# Service Bulletin

**Bulletin No:** 2007-1-08

**Subject:** Servomotor Clip

All 2007 F8, M8, and Crossfire Models

Fig. 1

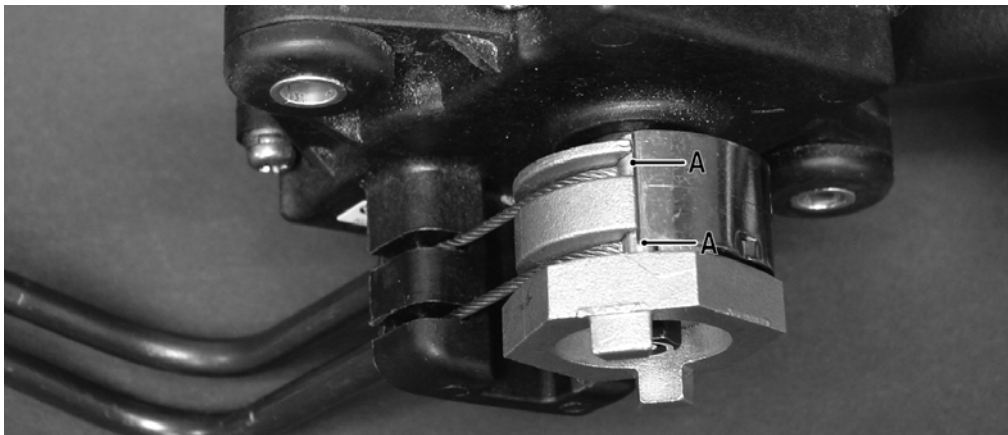
**Condition:** In some cases, the production servomotor clip may come into contact with the APV cables. If this condition should occur, the APV cables may become frayed and eventually break.

■ **NOTE:** When installing the new servomotor clip, be sure that the clip is positioned on the controller pulley with the wide end of the clip directly over the ends of the exhaust valve cables (A). See Fig. 1.

**Solution:** Replace the production servomotor clip with updated Servomotor Clip (p/n 5606-208).
